**Calaveras County Water District
Copper Cove, California
Bidding Documents
Copper Cove Phase 1 and 2 Tanks Project**

**ADDENDUM NO. 3
Issued August 7, 2023**

DRAWING C7

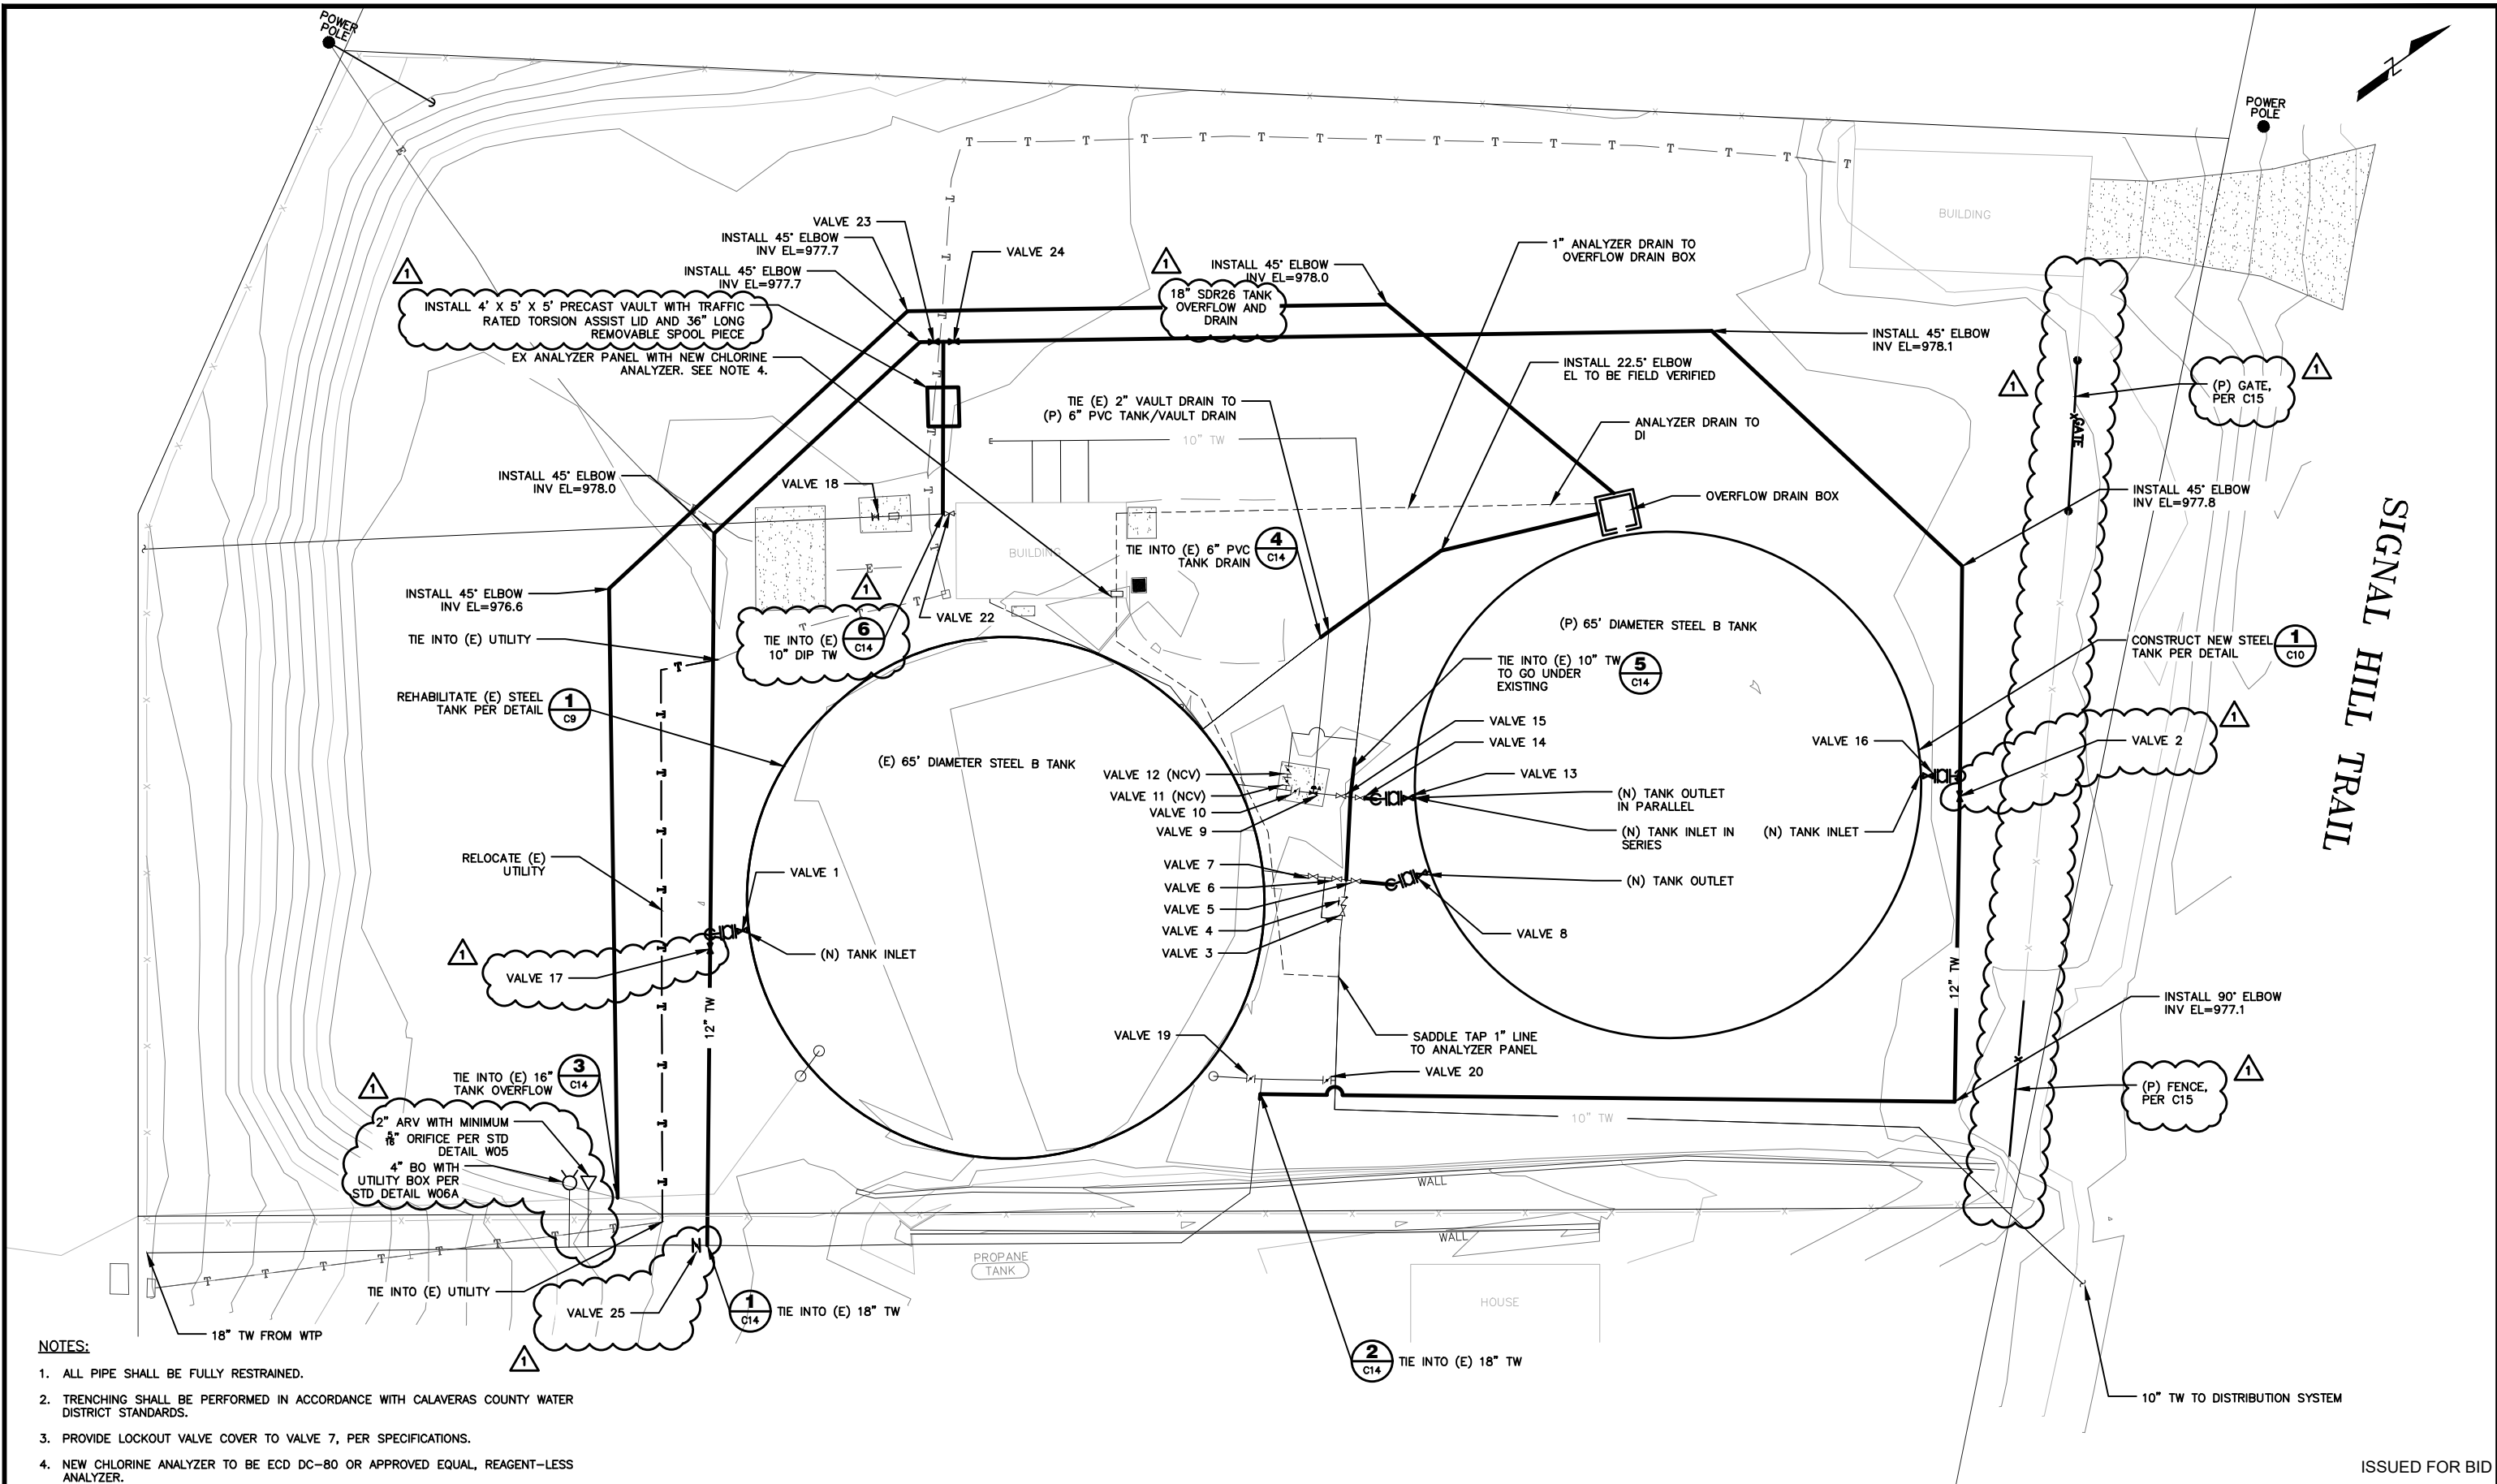
Question #9: Sheet C7 Clearwell Tank Site – At the 20” Transmission Main Tie-In, it calls for an 18” Wye to be installed with 2 valves. Please confirm the connection will be a transition from the 20” new Main to the exiting main using an 18” wye instead of a 20” Wye and what size the valves should be if we do connect to an existing 18” Line.

Question #22: Pursuant Drawing C7, 24” TW Outlet Line is called out (two locations) at invert elevation of 772.6’. Drawing C9A calls it out at 775.2’ and C11A appears to be at approximately 774’. Please confirm elevation of this line.

Question #23: Pursuant Drawing C7 and Detail 2/C13, can the existing tank be taken out of service to perform the tie-in?

Response #9: Per addendum 2 Attachment A, the wye shall be 18” with a reduction downstream from the wye to the new 20” transmission main.

Response #22: The 24” TW outlet line shall be at an invert elevation of 775.0 at the new clearwell. Refer to revised sheets C7 and C9A.

Response #23: Inline insertion valves have been added to C7 to accommodate the outlet tie-in as well as the tie-in to the 18" wye. Refer to revised sheet C7 and added specification sections 33 14 19: Valves and Hydrants herein.

- REHABILITATE (E) CLEARWELL PER DETAIL
- INSTALL 45' ELBOW INV EL=775.0
- 24" INLINE INSERTION VALVE 8.5 FT FROM OUTSIDE TANK WALL PER SPECIFICATIONS. VALVE 11

- 18" INLINE INSERTION VALVE PER SPECIFICATIONS. VALVE 10
- 18" X 20" REDUCER DOWNSTREAM OF VALVE 9
- INSTALL 18" WYE WITH TWO 18" BFVS
- REPLACE EXISTING 18" C900 PVC WITH APPROXIMATELY 60 LF OF NEW 18" DIP UP TO EXISTING COUPLING (APPROXIMATELY 5 FEET FROM THE OUTSIDE FACE OF EXISTING WALL). REPAIR ASPHALT AS NEEDED.

DRAWING
C8

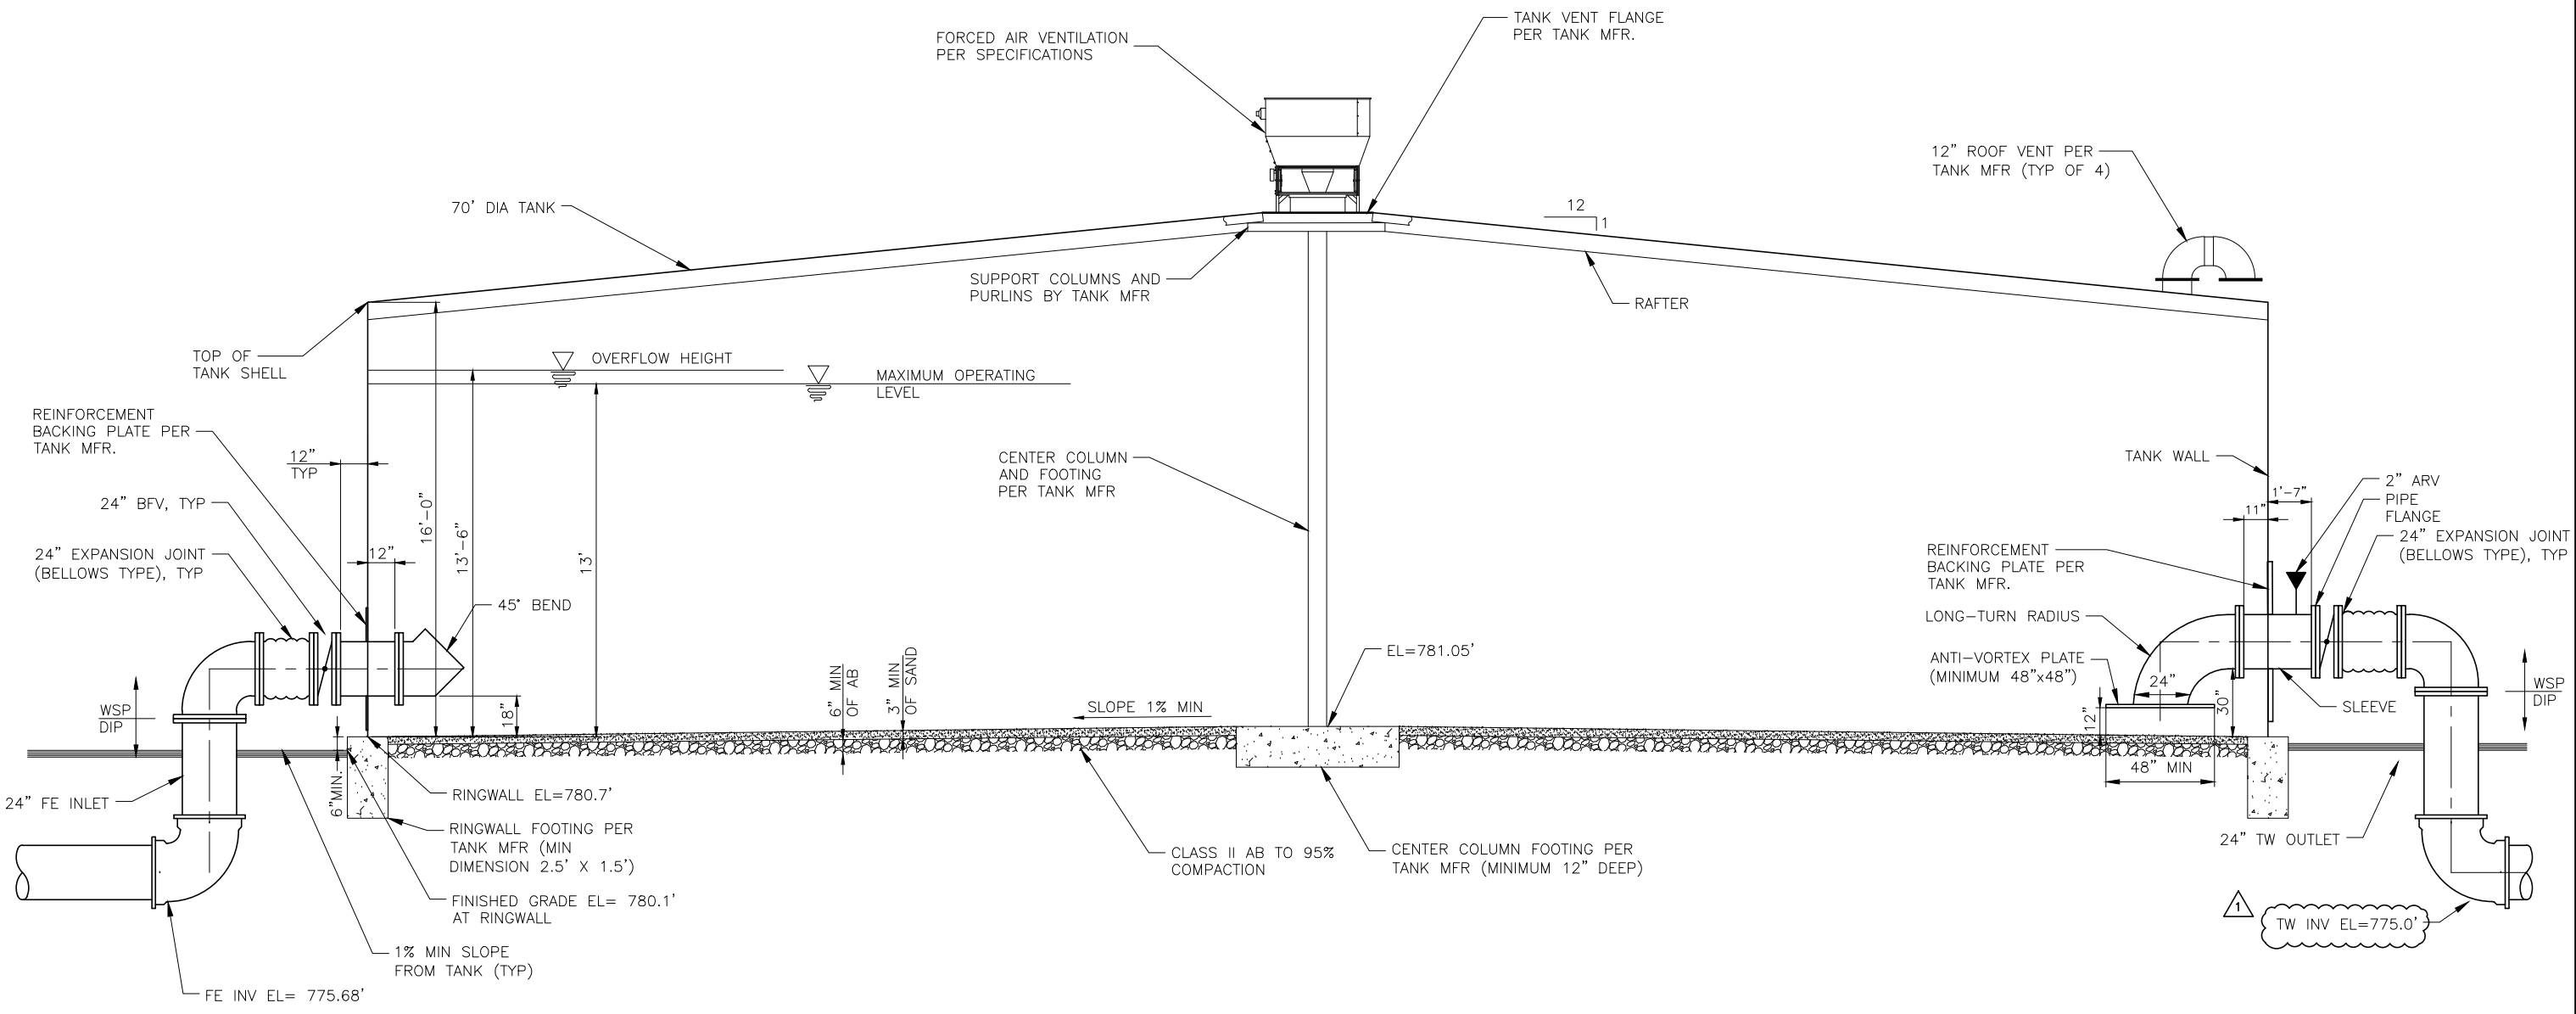
Question #2: Sheet C8 shows a line from the new 12” TW line that ties in to the existing 10” BPS effluent line outside of the B Tank booster pump station building that includes an altitude valve vault with a 36” removable spool piece. Is this line intended to be 10” or 12”? Is the altitude valve being relocated from another location or provided by the utility? Could you provide a detail for the vault and piping? Could you provide a detail for the tie-in to the existing 10” BPS effluent?

Question #24: There is mention of chlorine analyzers on drawing(s) C7 and C8 but not specs. Please advise.

Response #2: The altitude valve will be procured as part of a future project. This line is intended to be a 12” line, see revised sheets C8 and C14 included in Attachment A.

Response #24: Per note 4 on C7 and note 4 on C8, new chlorine analyzer to be ECD DC-80 or approved equal, reagent-less analyzer.

EXISTING 10" TREATED WATER TIE IN DETAIL 6
1/2" = 1' C8

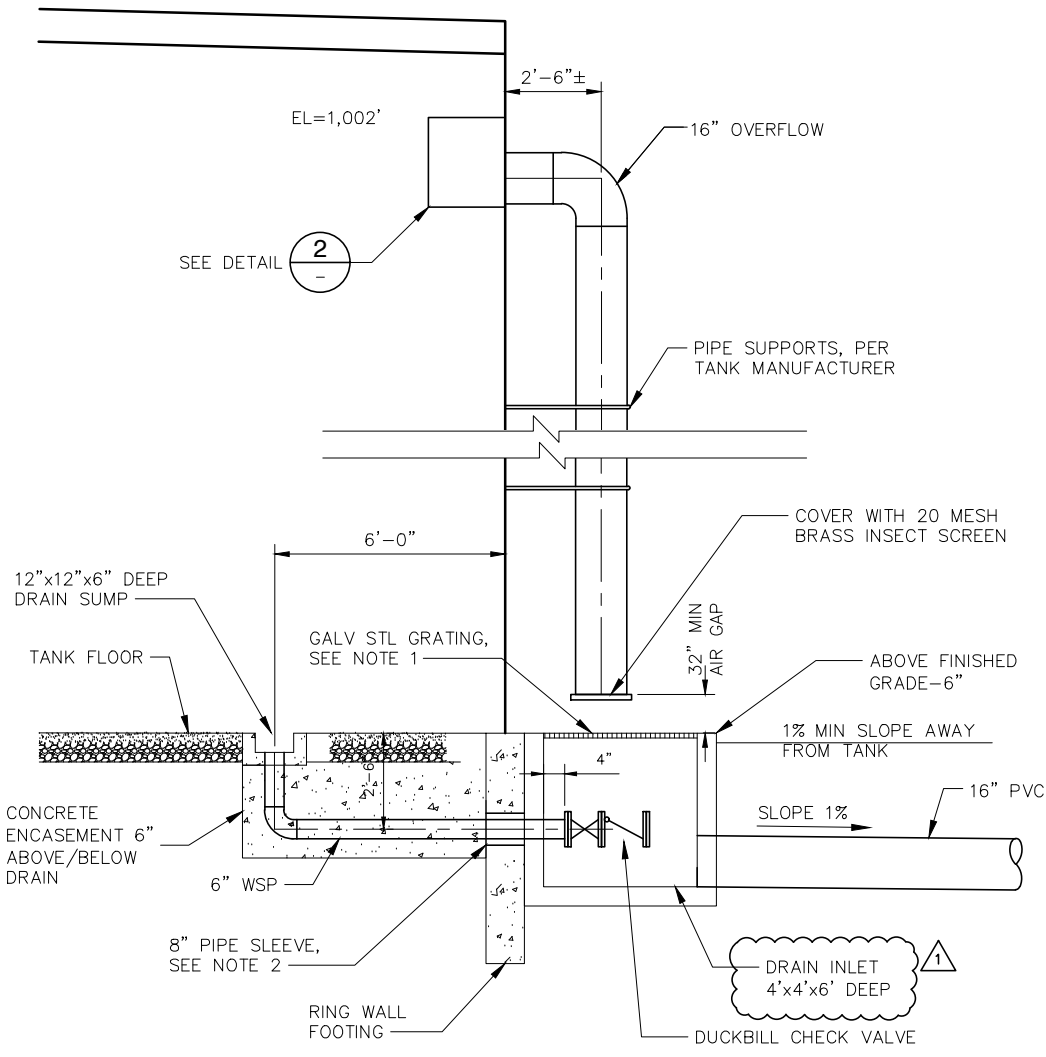
Question #25: Specification Section 01 74 19, Paragraph 1.05 Asbestos Demolition Procedures, where is this pipe located, size and lengths? This information is required to accurately price the disposal.

Response #25: Approximately five (5) feet of 10" diameter AC treated water pipe is being removed. Refer to revised Detail 5 on sheet C14 herein.
